Info Only: Comments from Service
Engineering are in blue text.

CHRIS TEAM SUBDIVISION

FINAL DRAINAGE REPORT

ALL TERRAIN ENGINEERING PROJECT NO: 24019

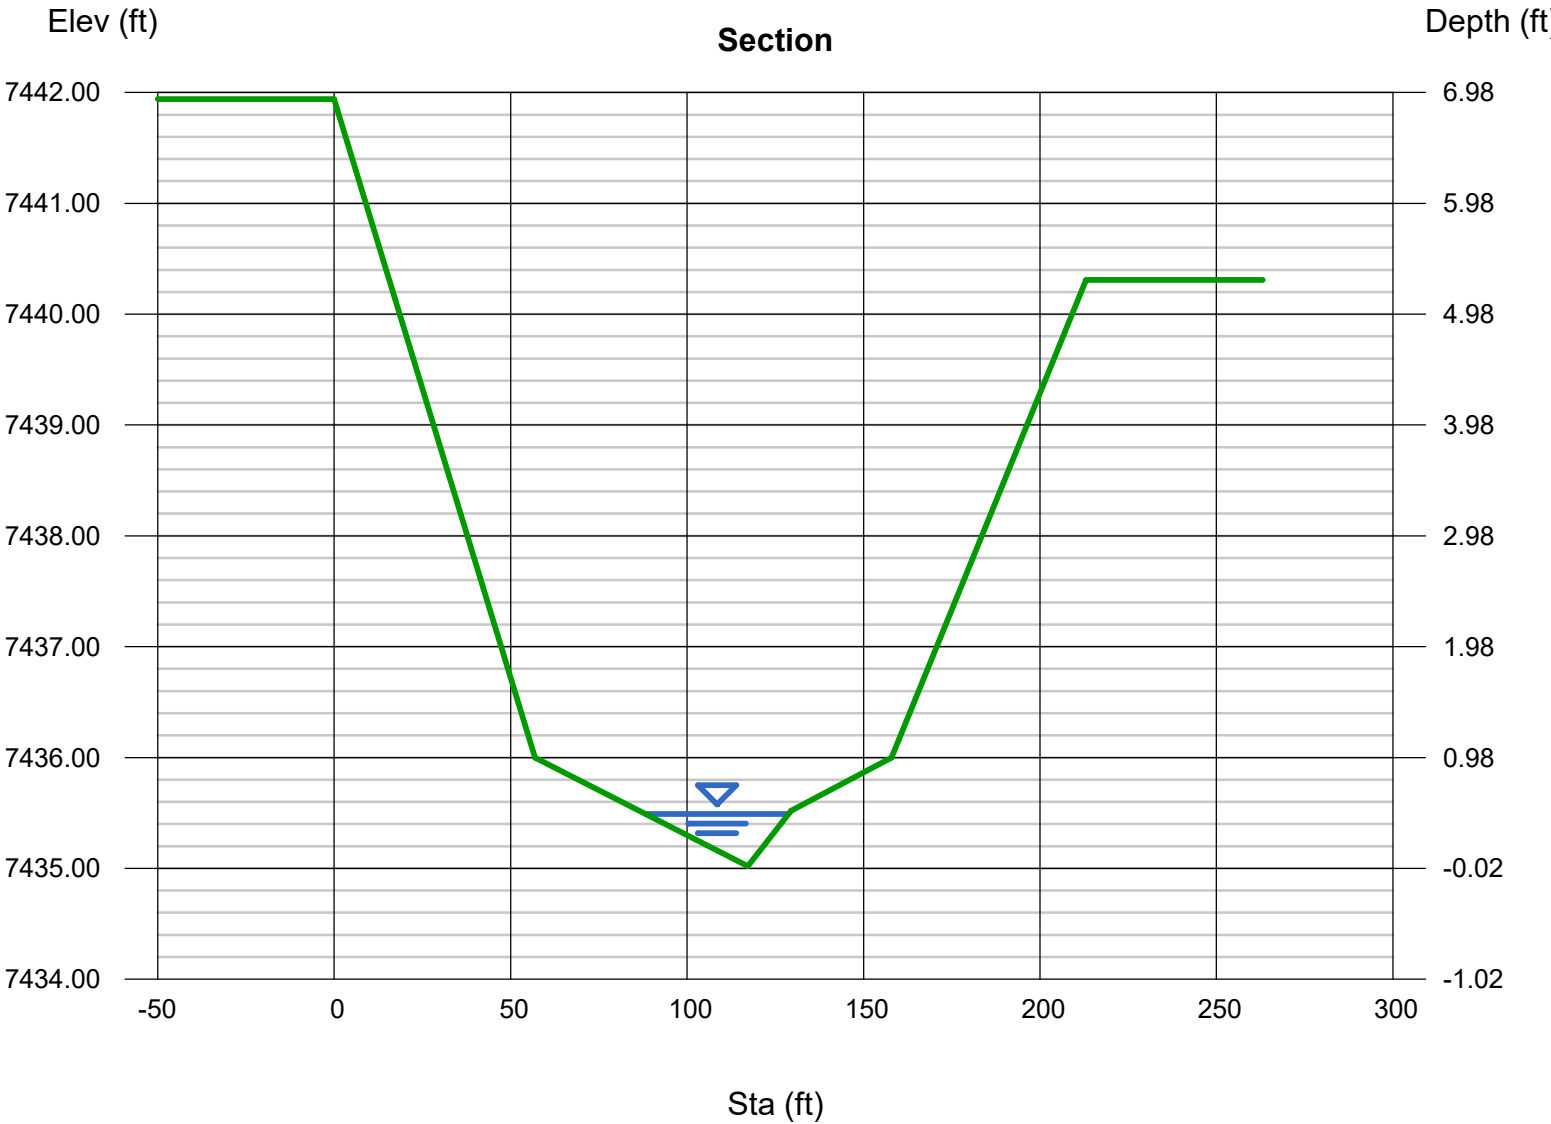
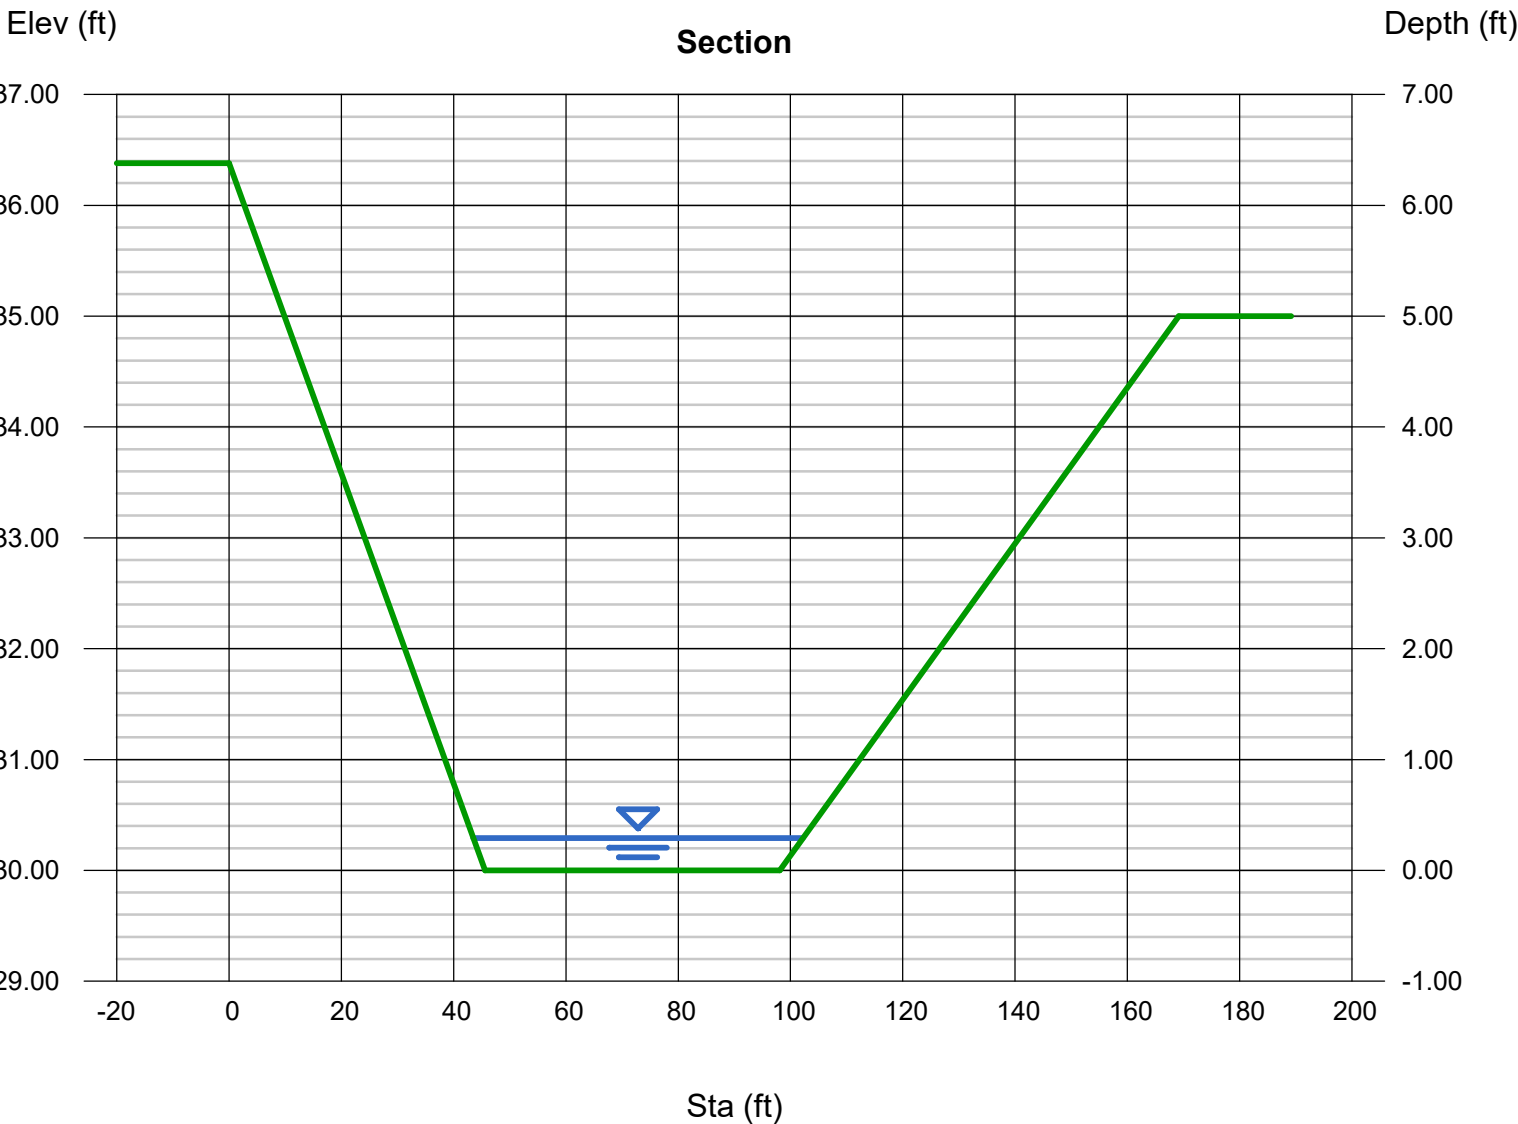
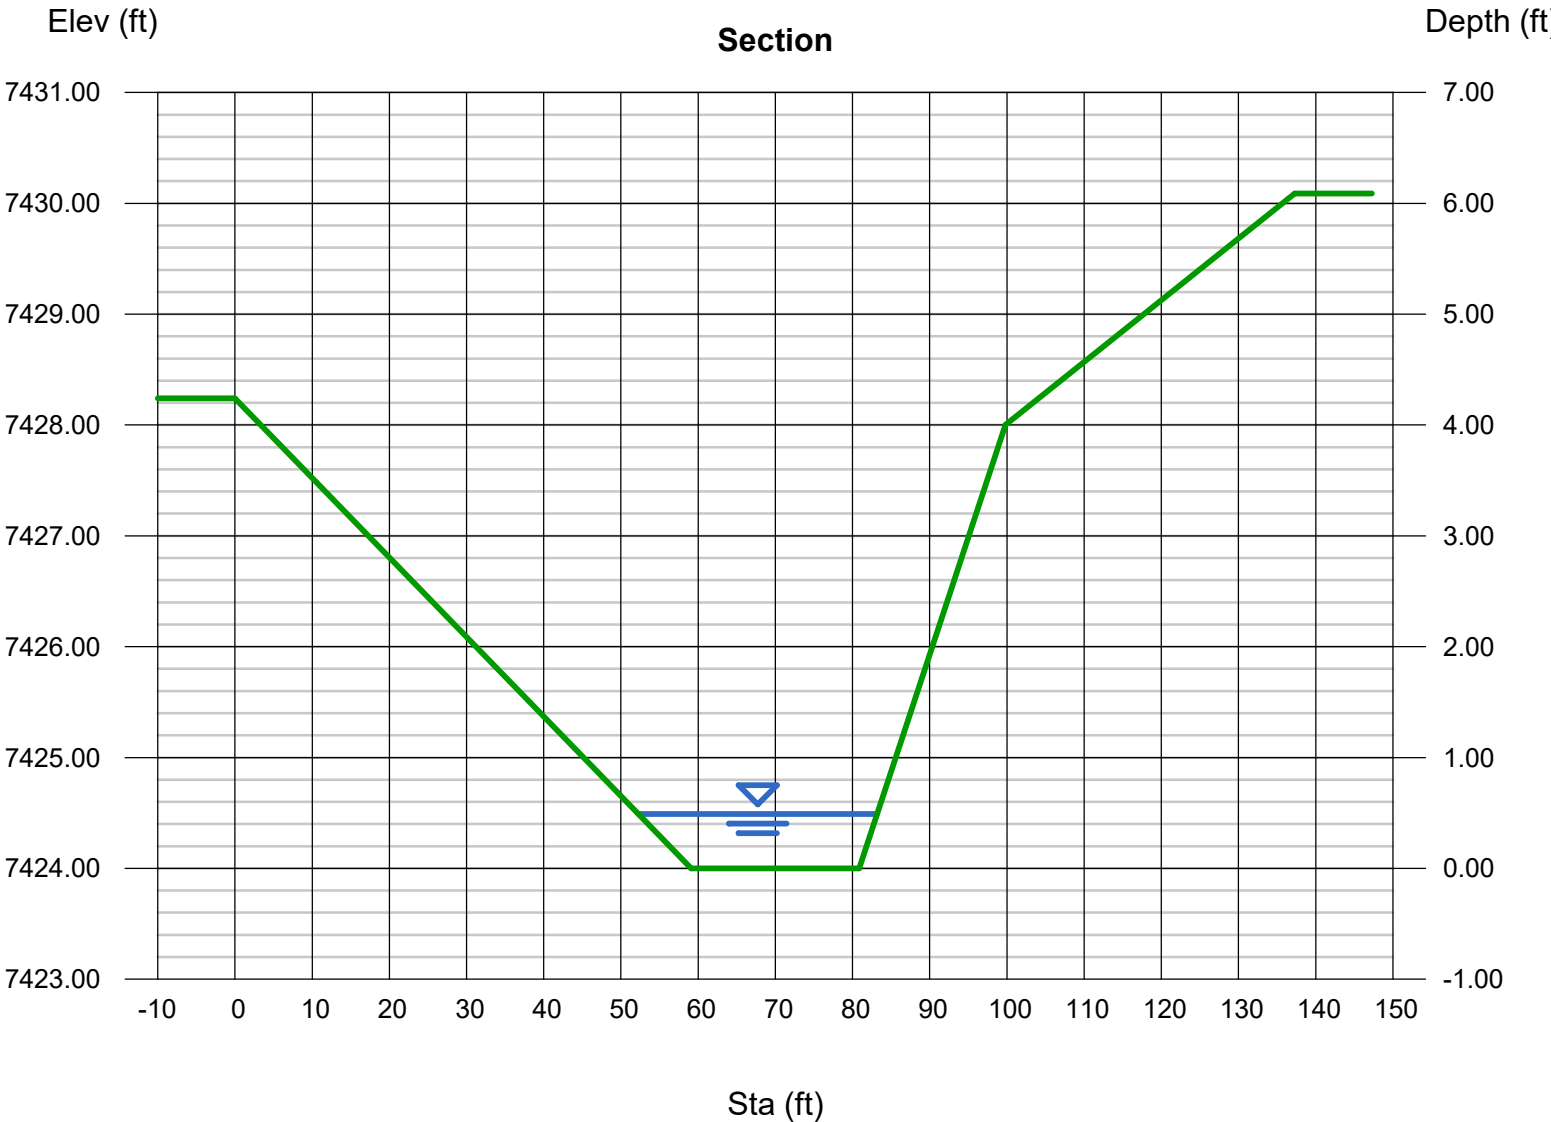
Please describe the ability of the ditch along the west side of Black Squirrel Road to handle the flows from the site and whether improvements will be needed.

ATE RESPONSE: ADDRESSED. SEE REVISED TEXT AND OVERTOPPING ANALYSIS.

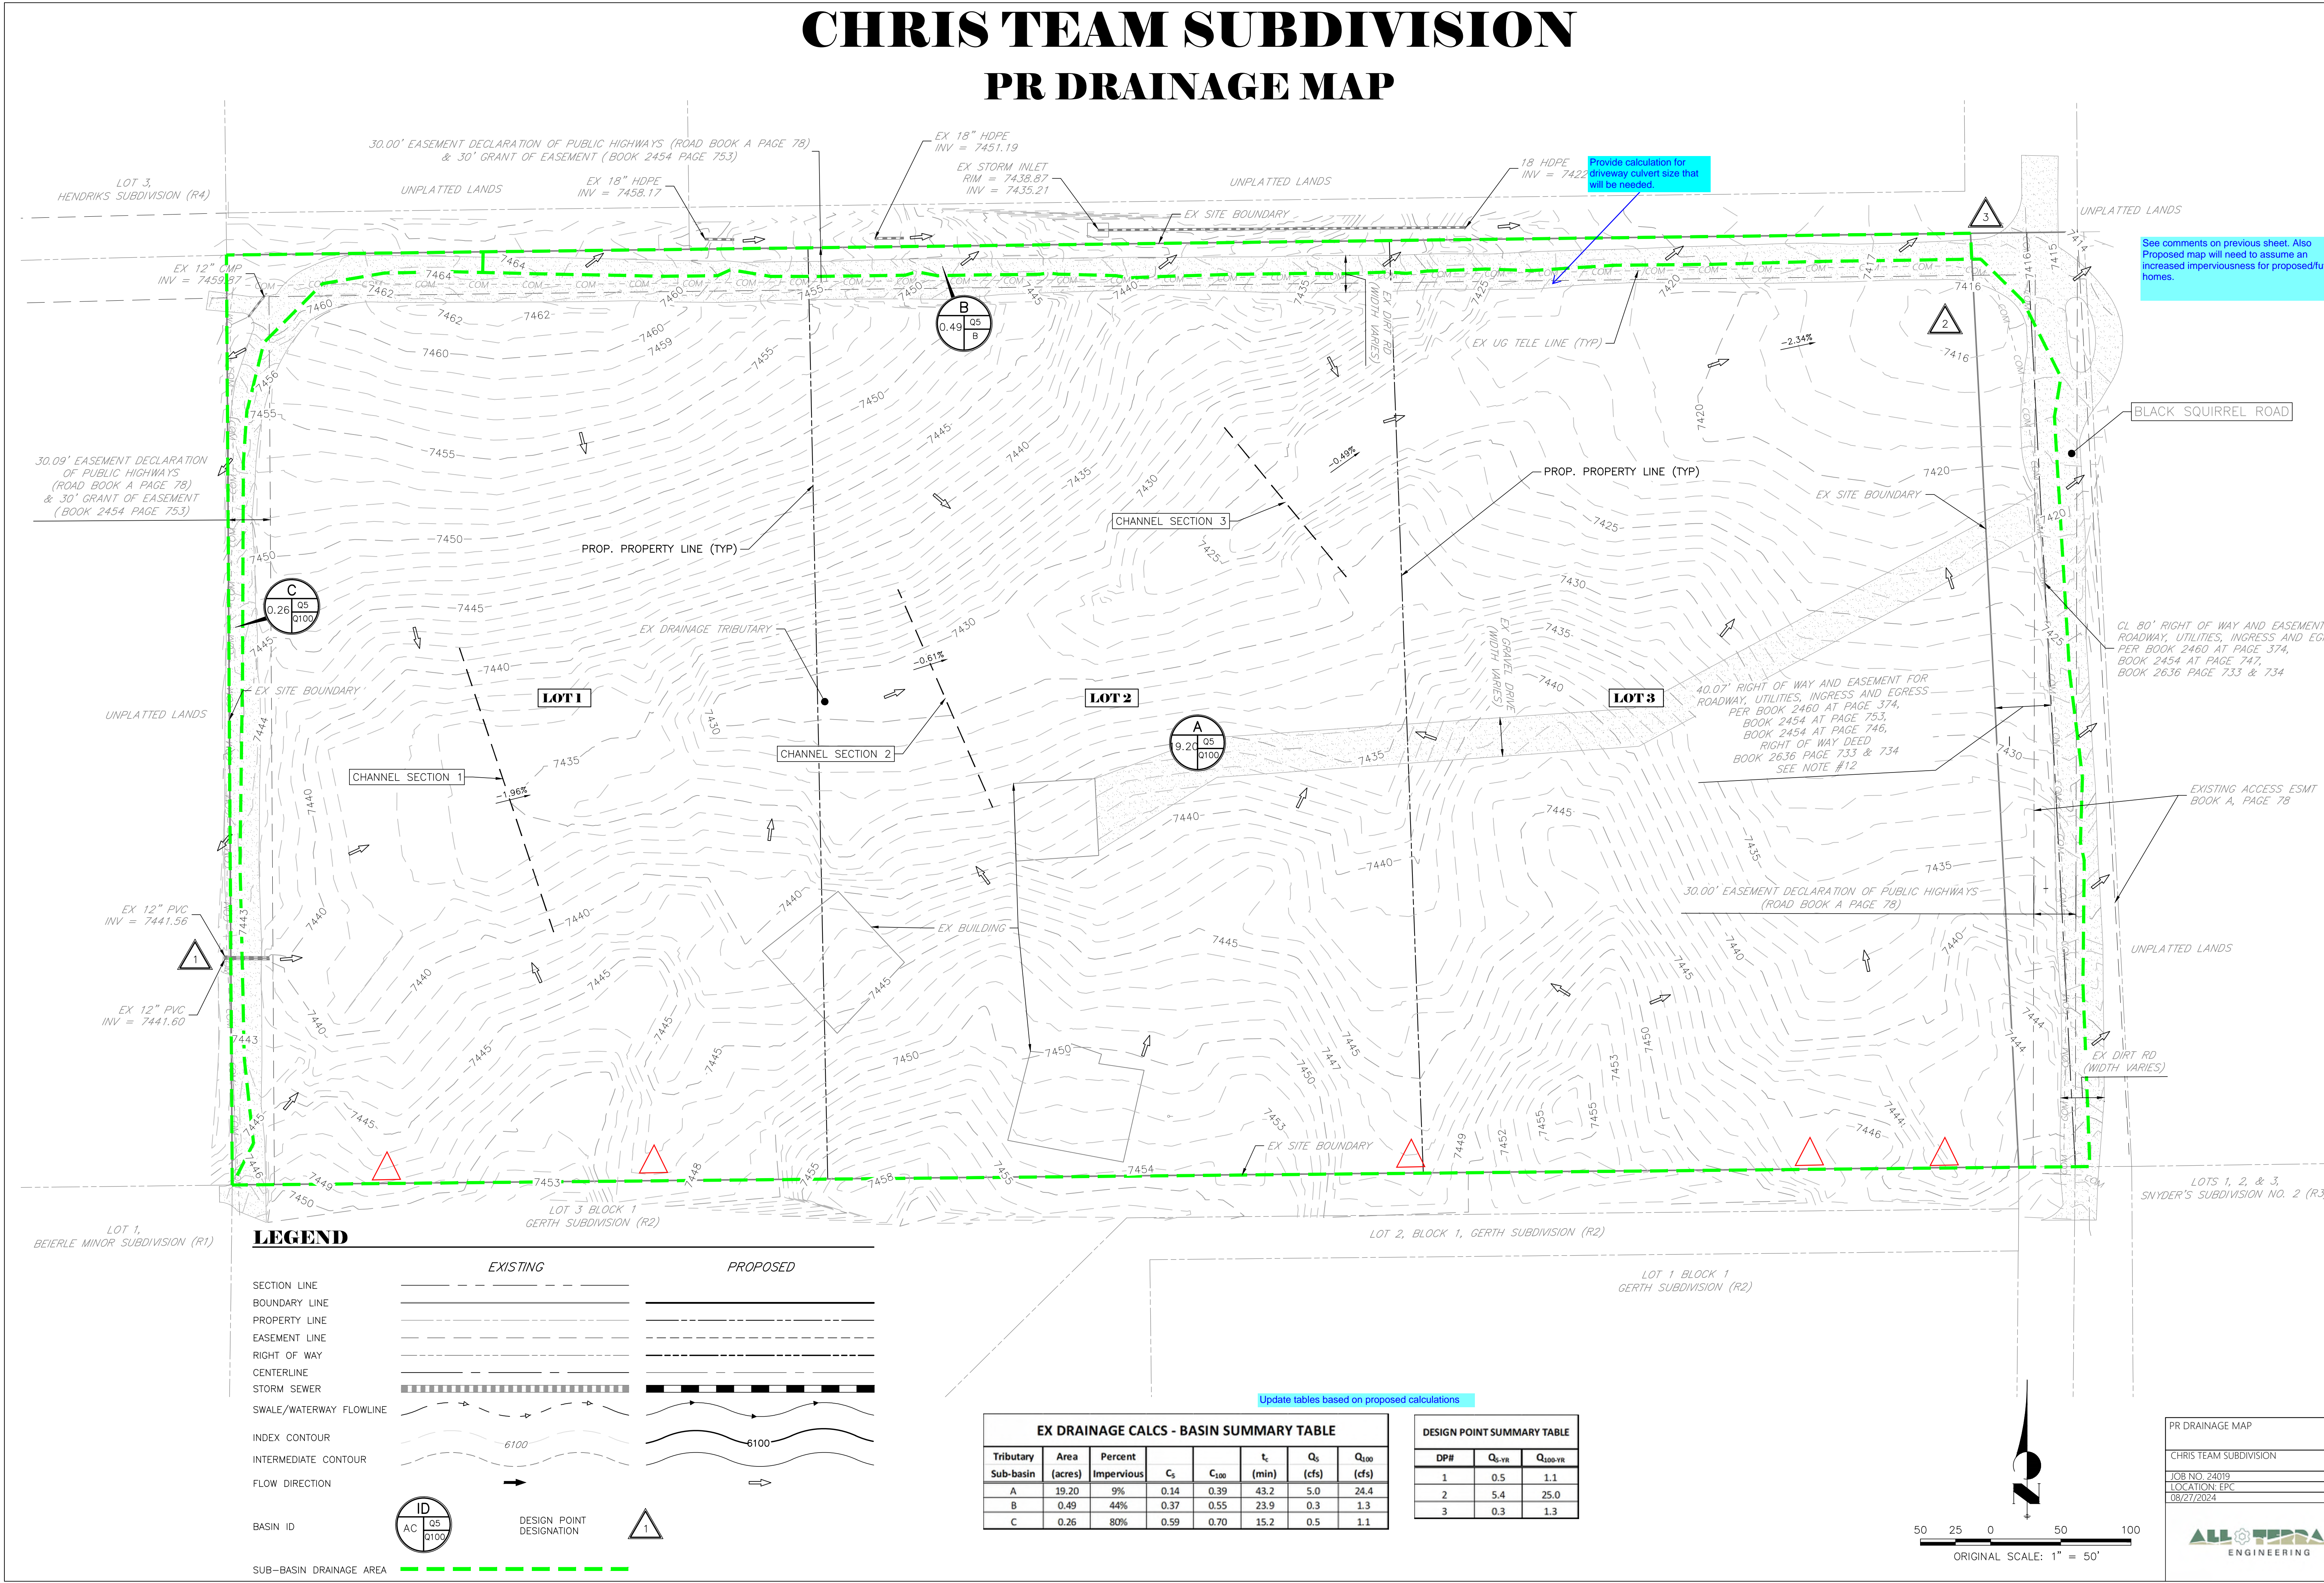
Indicate how flows exit site and show where flows go downstream

Add flows

Please expand the view to show contours for offsite flows entering from the West and South.

ATE RESPONSE: ADDRESSED. ADDITIONAL OFFSITE BASINS HAVE BEEN ADDED TO DELINEATE OFFSITE FLOW. BASIN A WILL NOT BE BROKEN INTO ADDITIONAL BASINS AS NO DRAINAGE INFRASTRUCTURE IS BEING SIZED UPSTREAM OF BASIN A'S DESIGN POINT 2.

ATE RESPONSE: ADDRESSED. SEE REVISED BASIN A AND B DESCRIPTIONS. OVERLAPPING ANALYSIS OF BLACK SQUIRREL ROAD IS PRESENTED IN APPENDIX C.

ATE RESPONSE: ADDRESSED. MAP HAS BEEN UPDATED TO REFLECT CORRECT PROPERTY

ATE RESPONSE: ADDRESSED.
